ADDENDUM NO.5

PROJECT - ECA @ CEC Modernization, Renovation & Addition

RFP NO. 21-032 RRR
APS PROJECT # 507
NIGP Code: 90927; 90928; 909

PD101
ADDENDUM No. 5
EXHIBIT 04

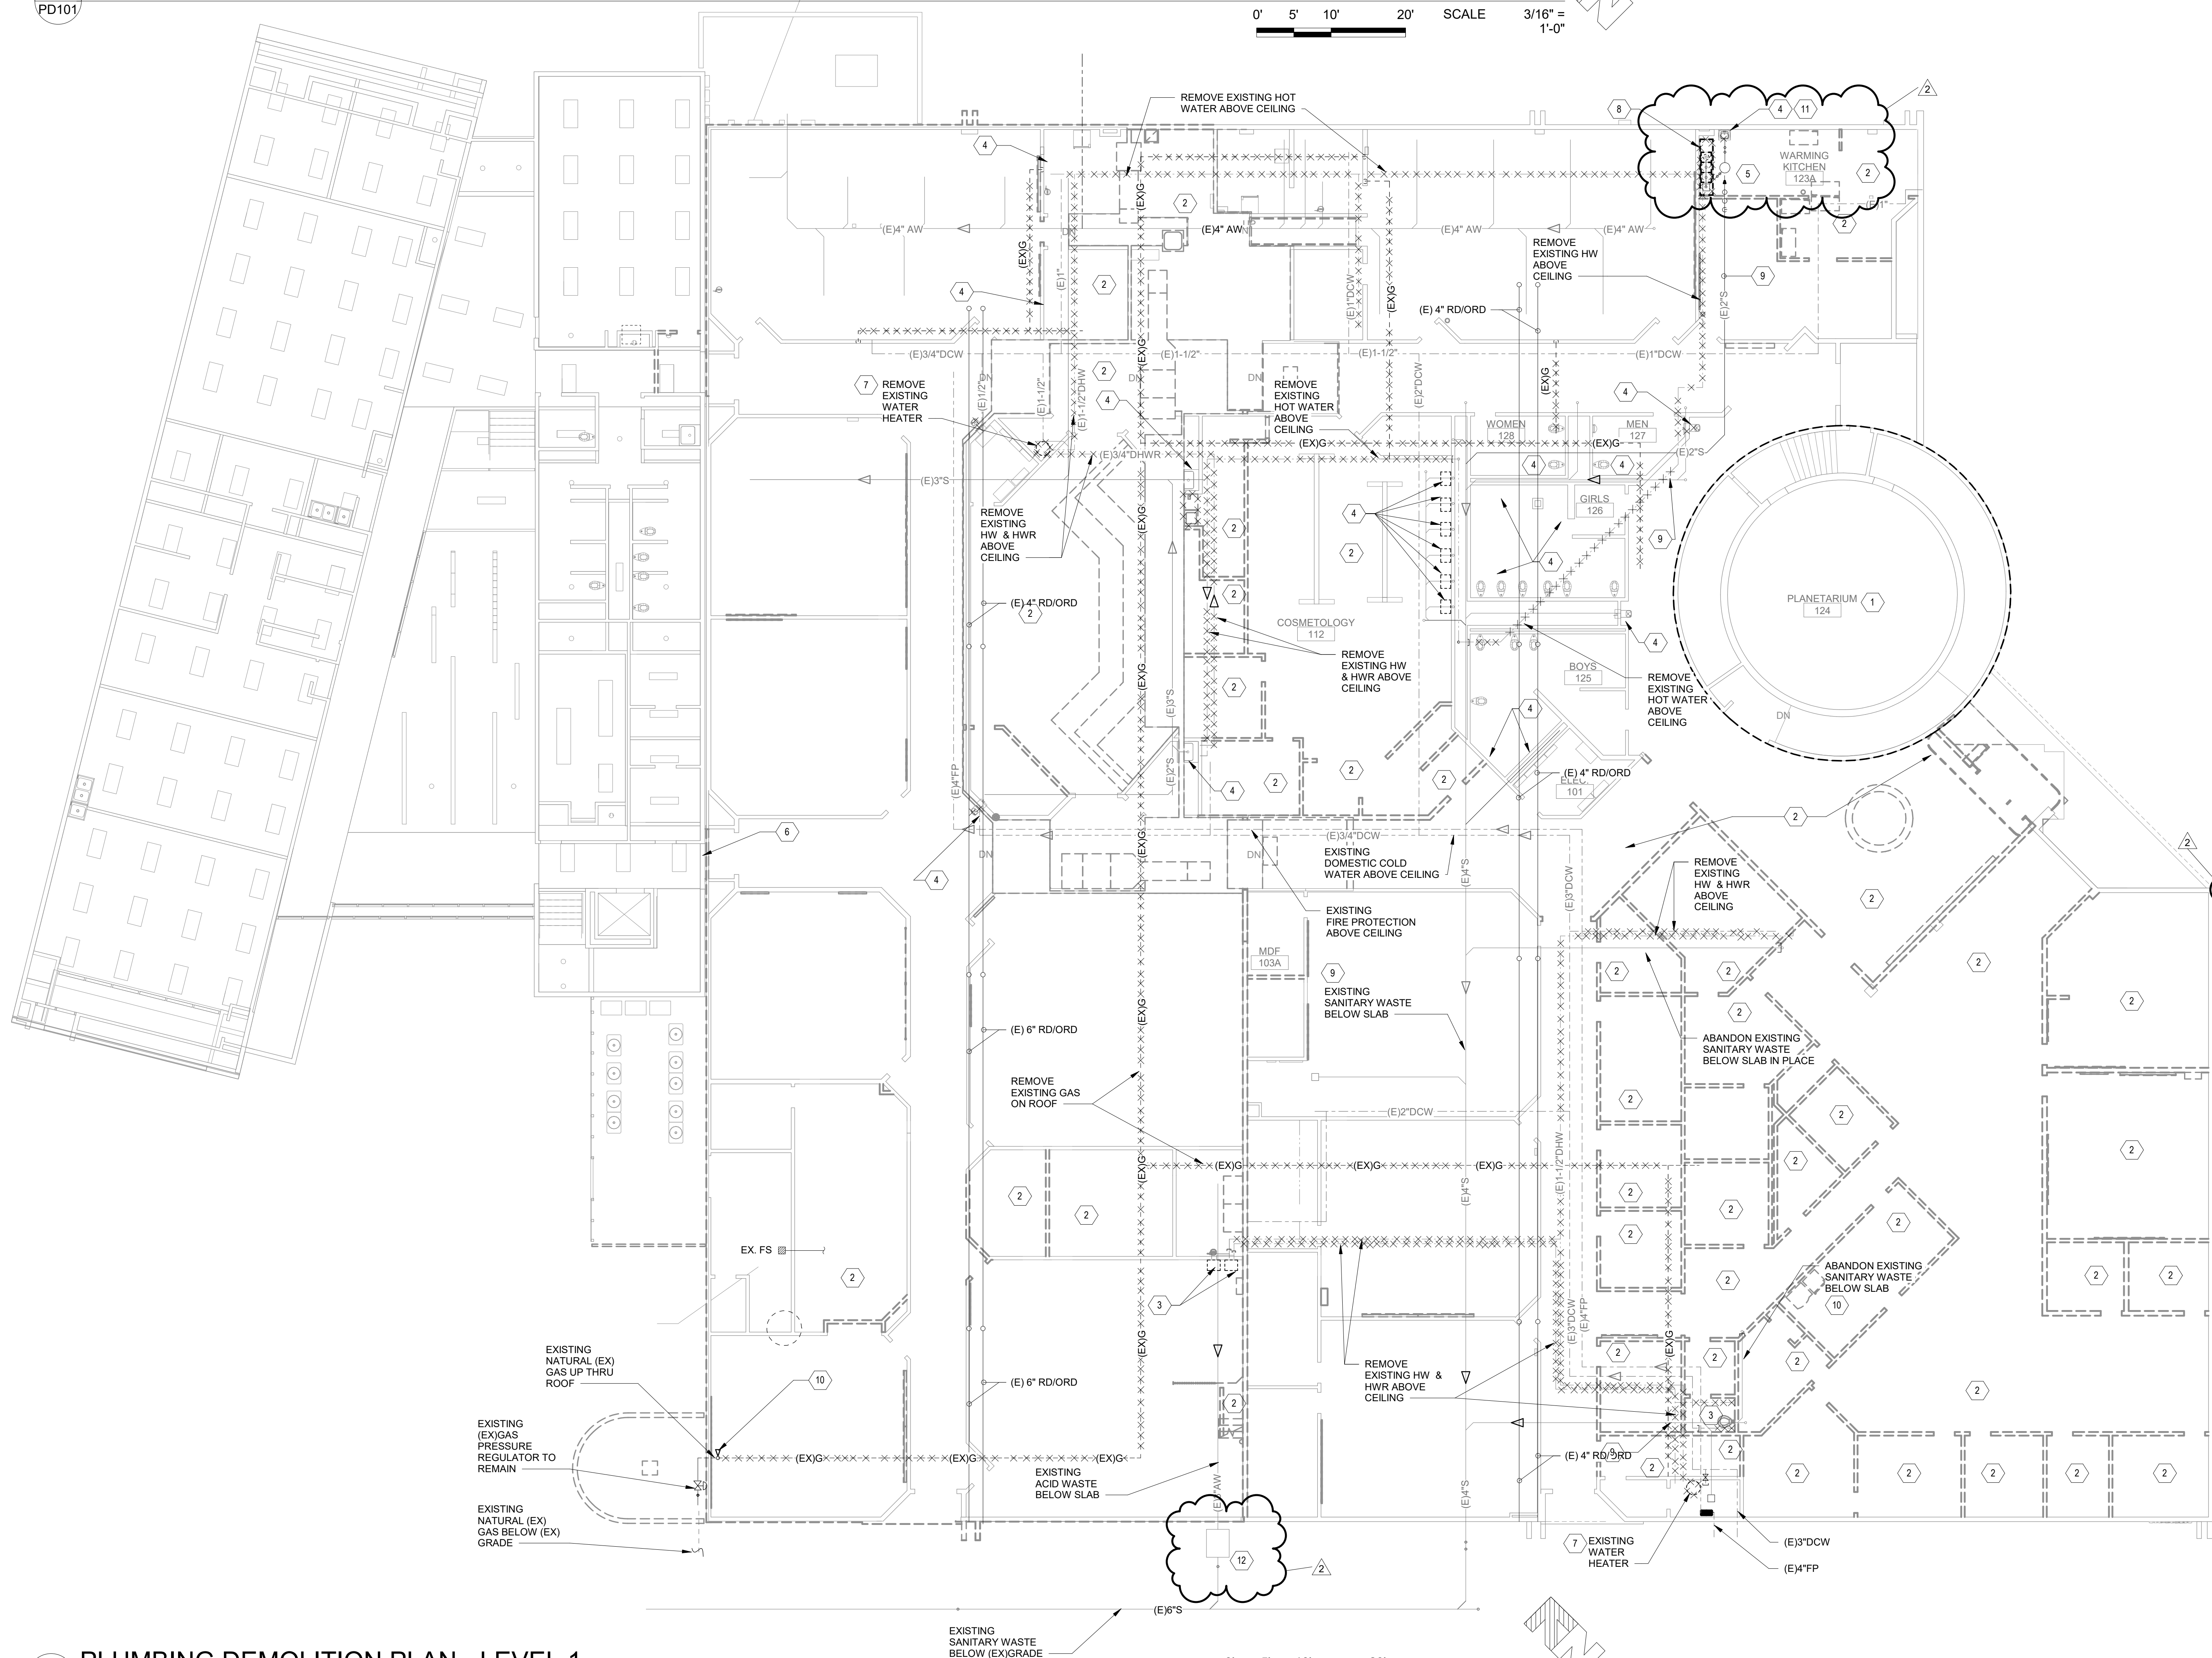
- a. **General:**
The natural gas meter is not being relocated. The intent is to connect the new 2” gas line at the existing meter location.
- b. Change KN #5 per the attached **EXHIBIT 04**.
- c. ADD KN #12 indicating the remove the acid neutralization pit.

A1 WASTE & VENT FLOOR PLAN PL101

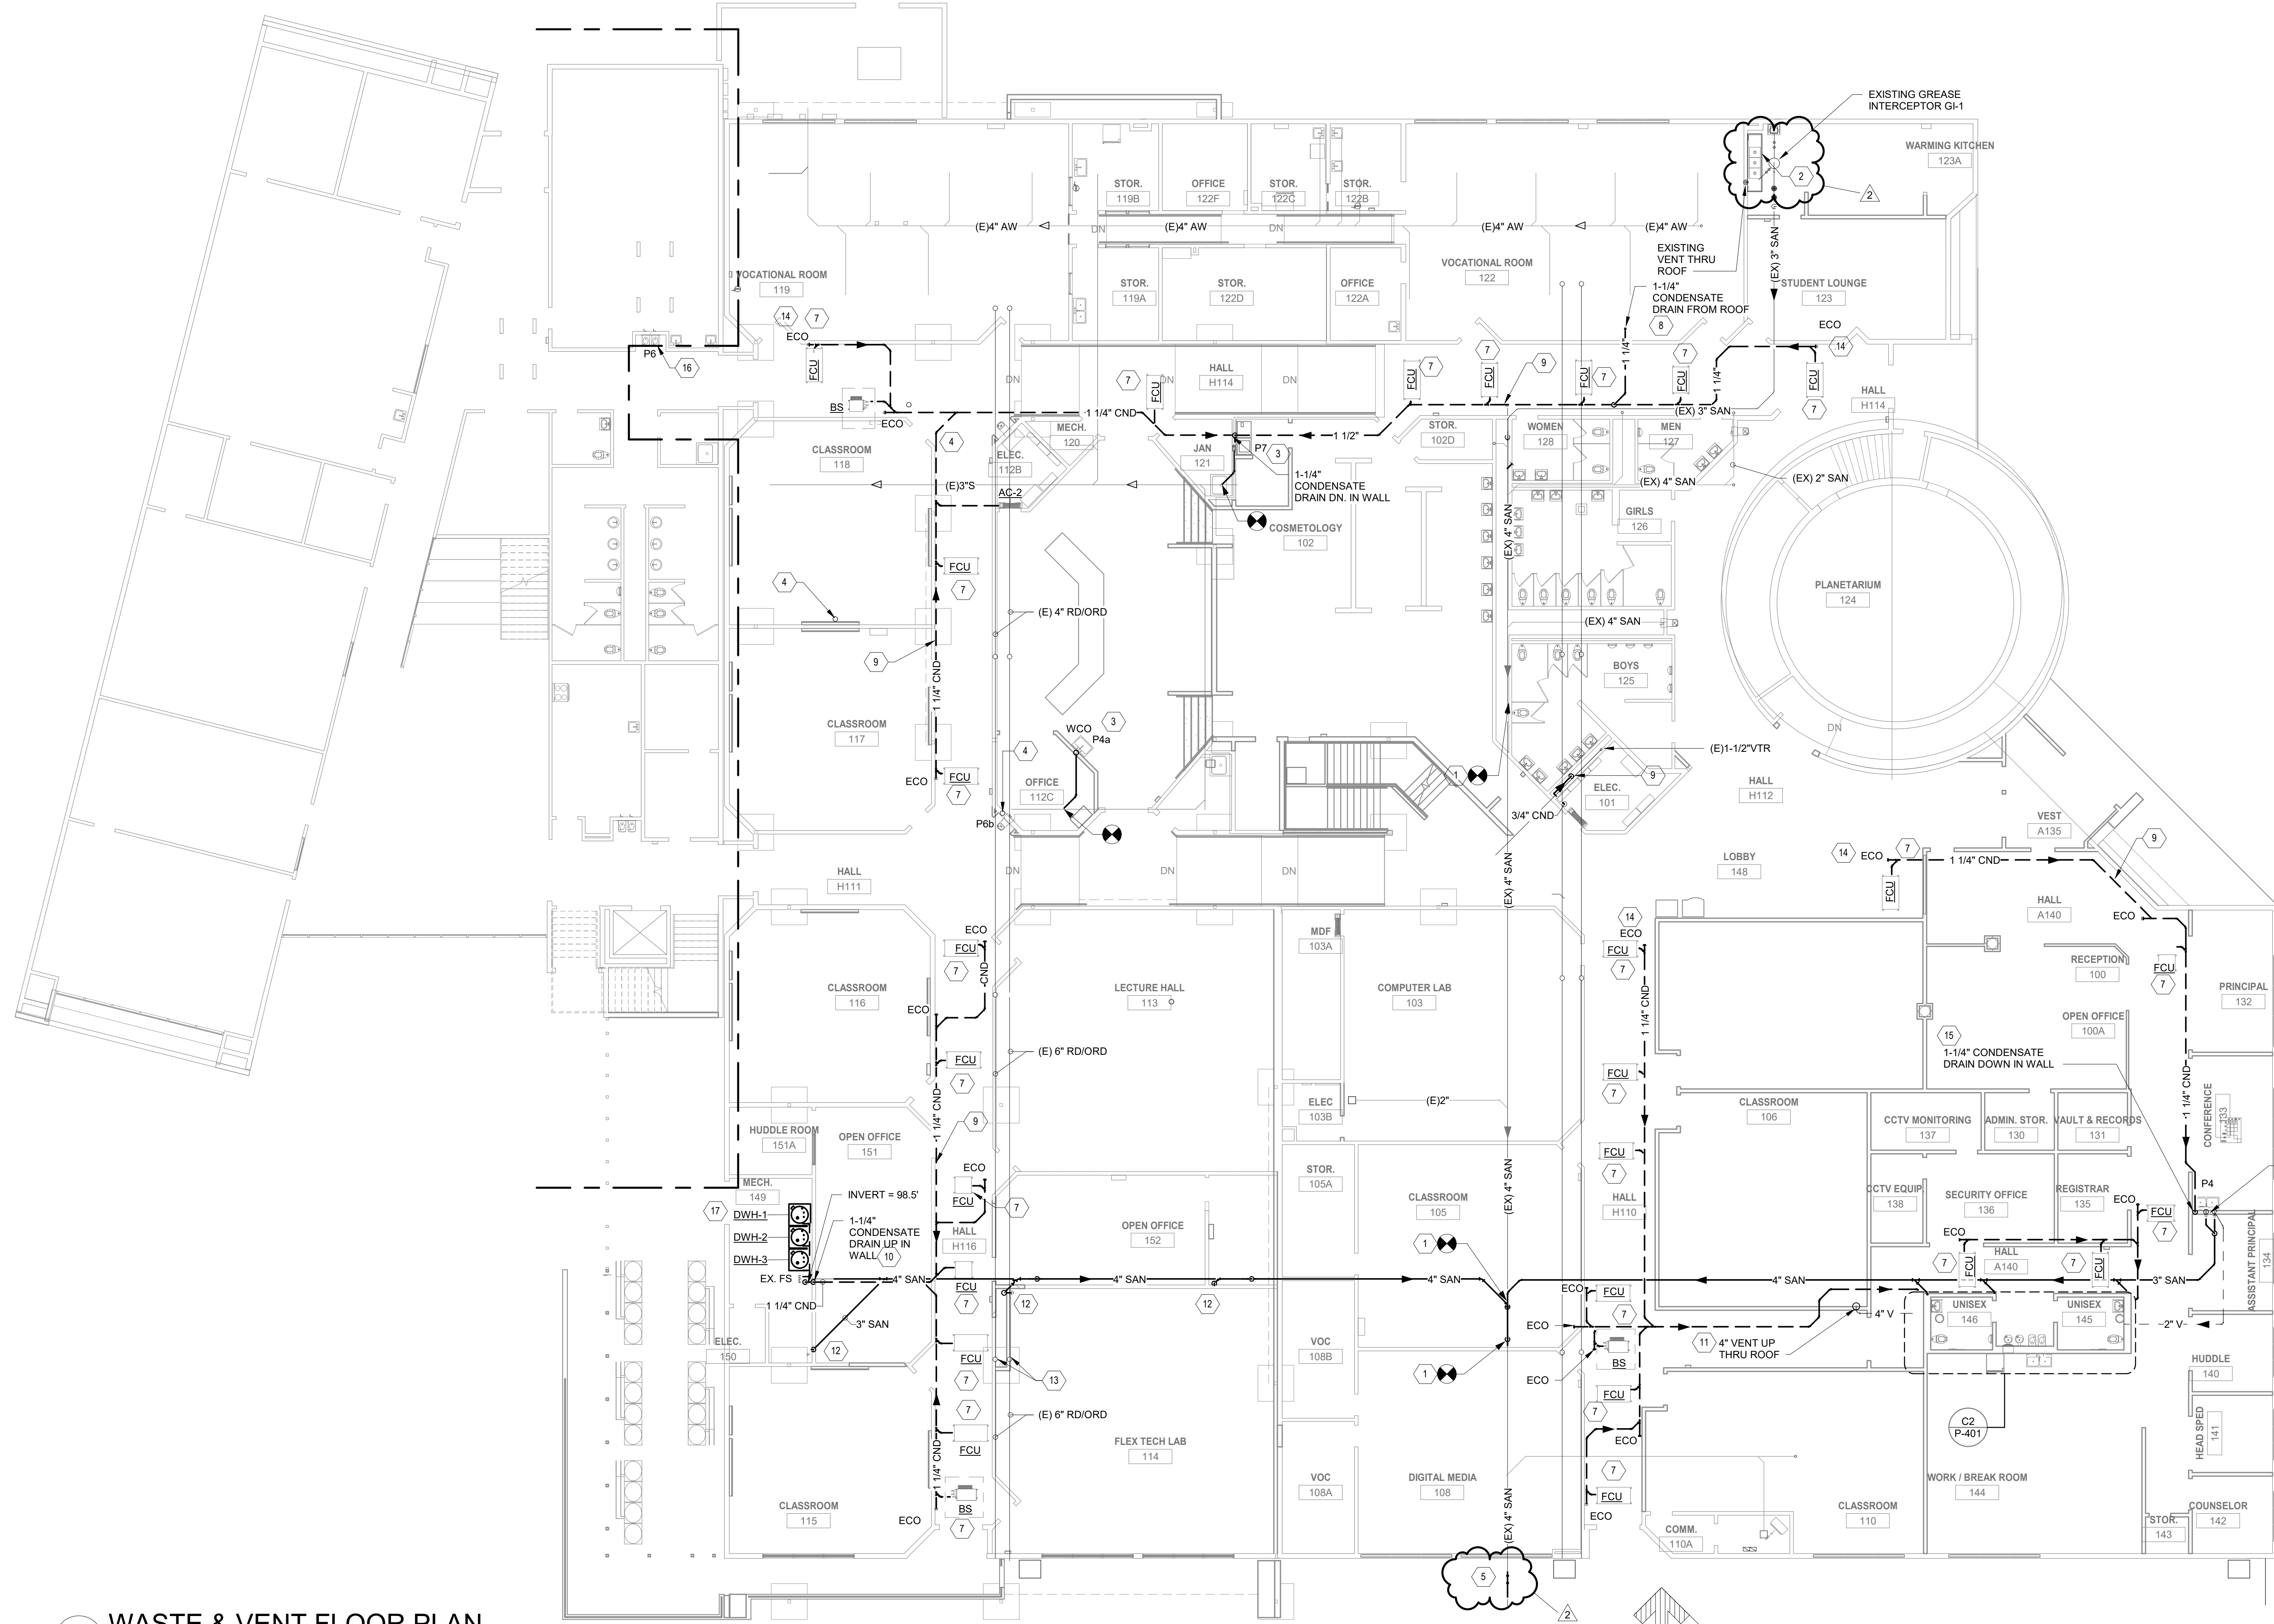
- a. ADD KN #2 and #5 per attached **EXHIBIT 05**.

A1 ED101 ELECTRICAL FLOOR DEMOLITION PLAN

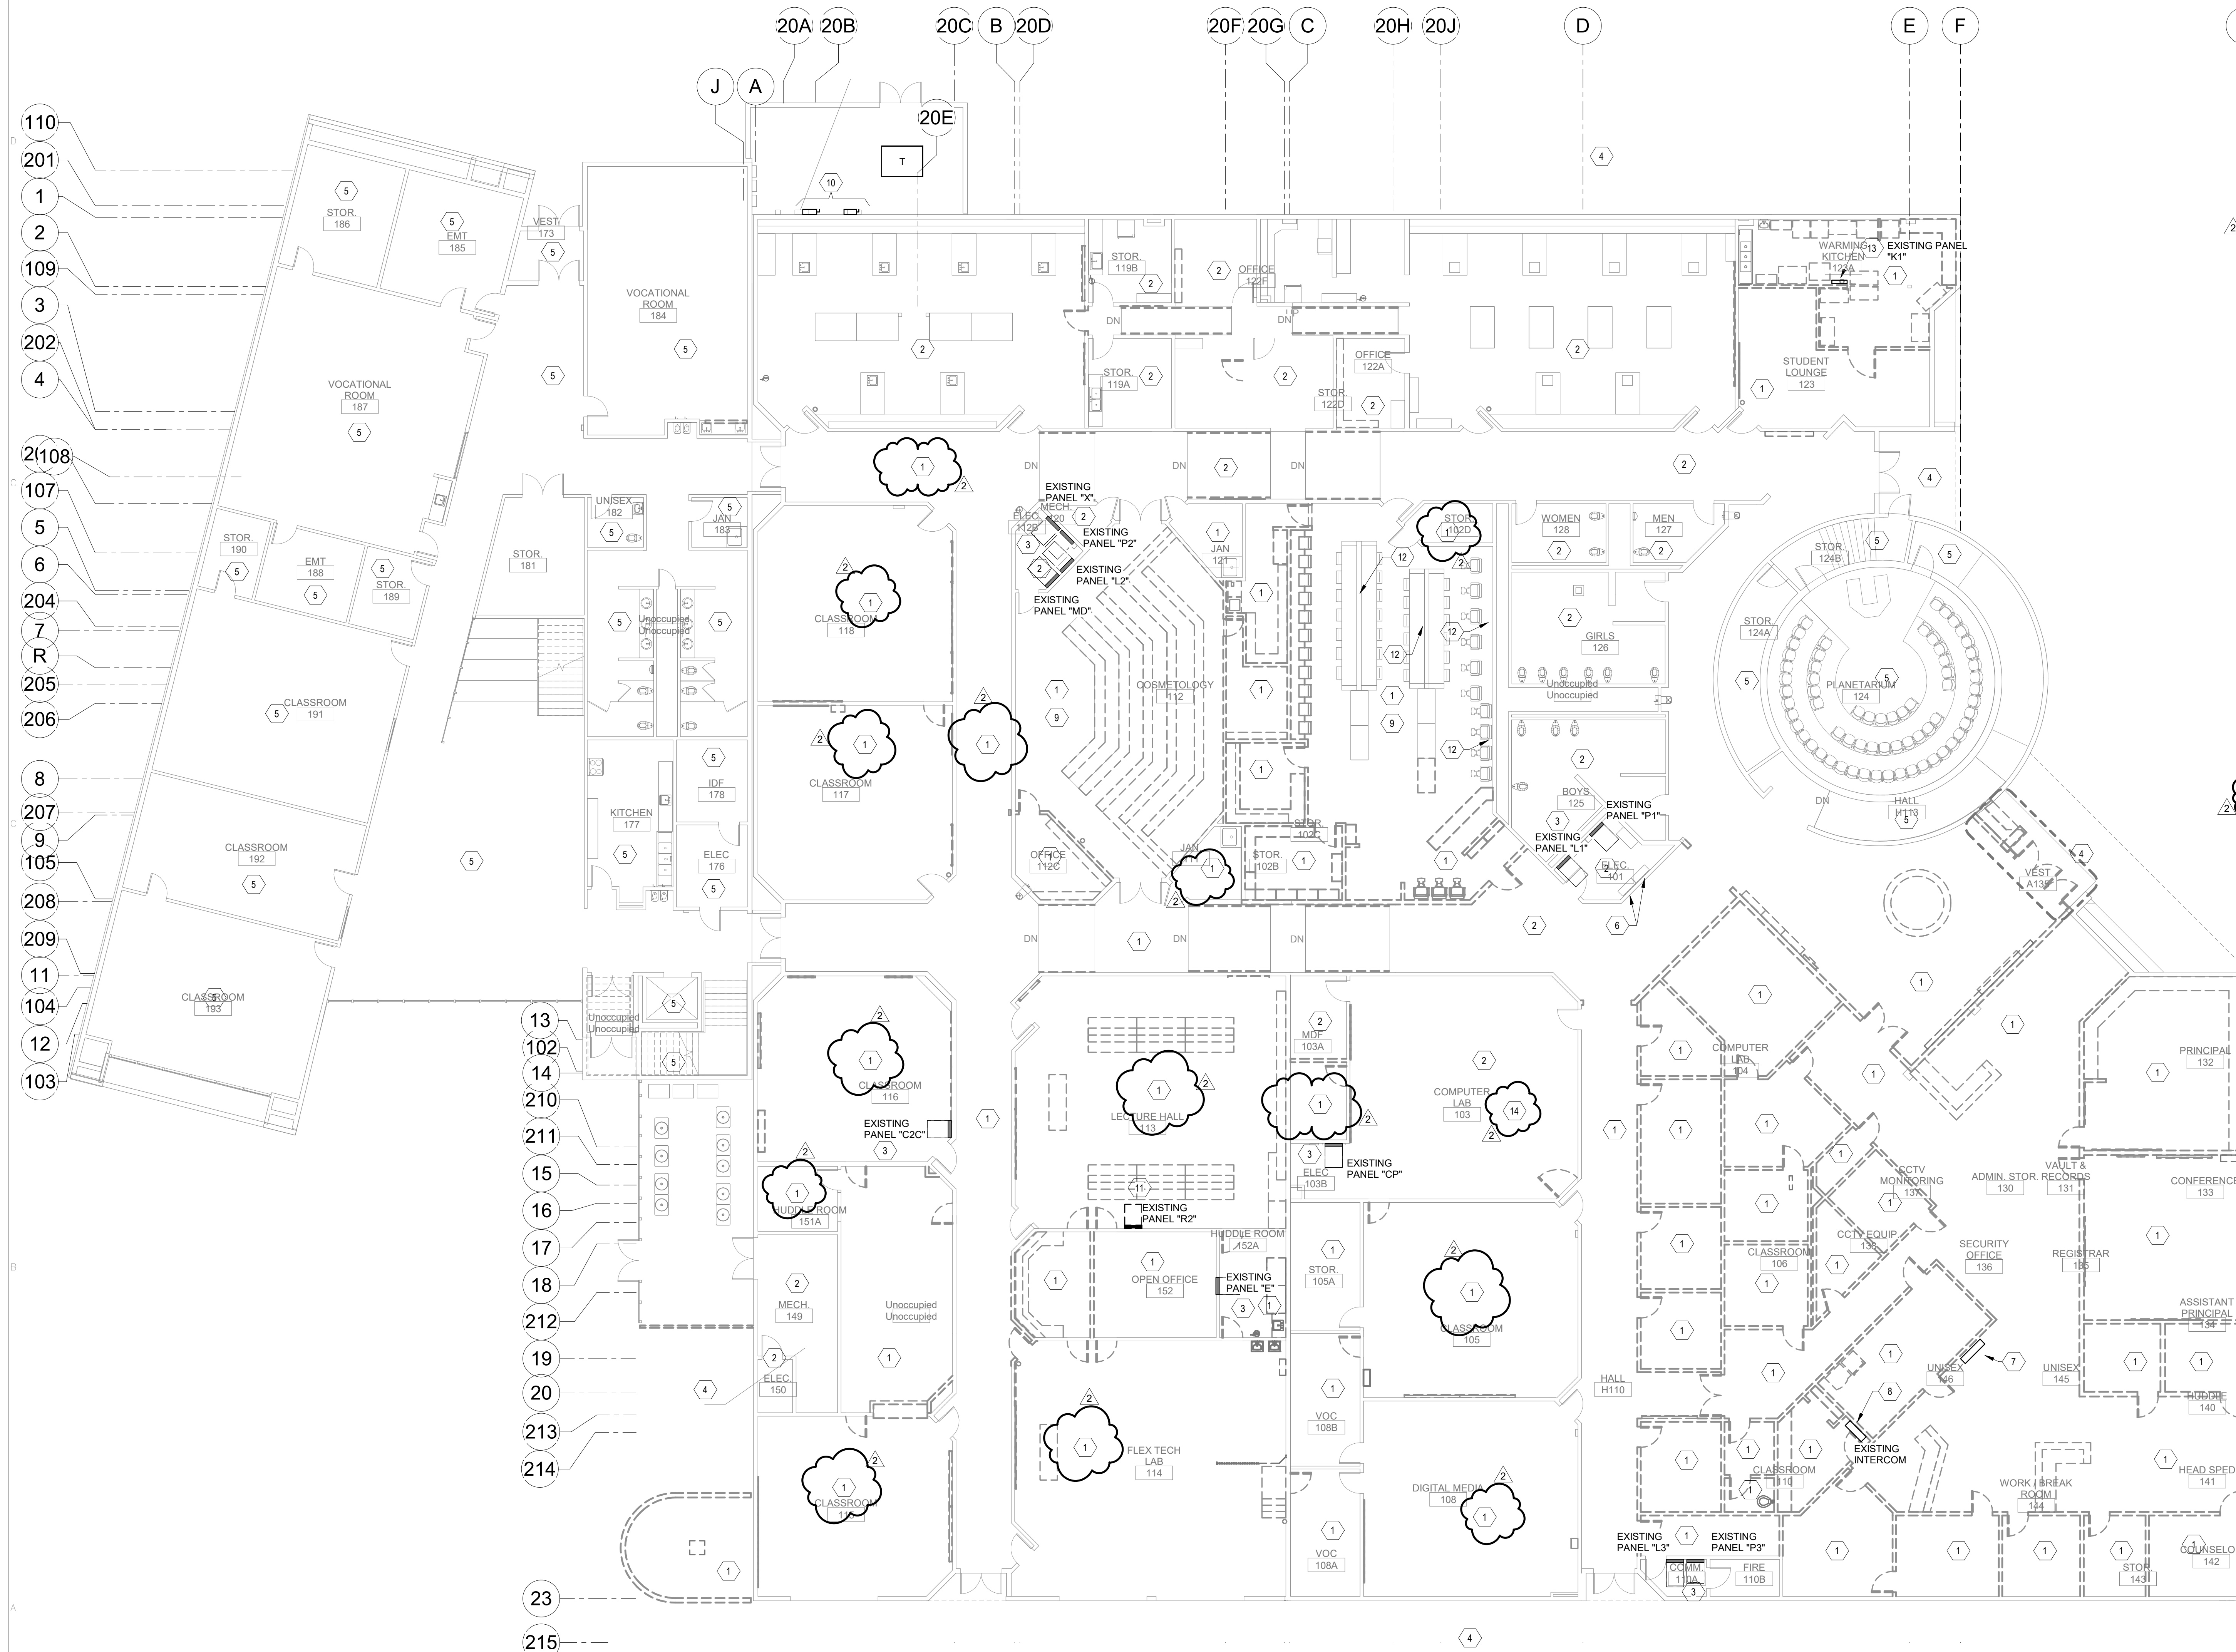
- a. ADD additional demolition requirements per attached **EXHIBIT 06**.
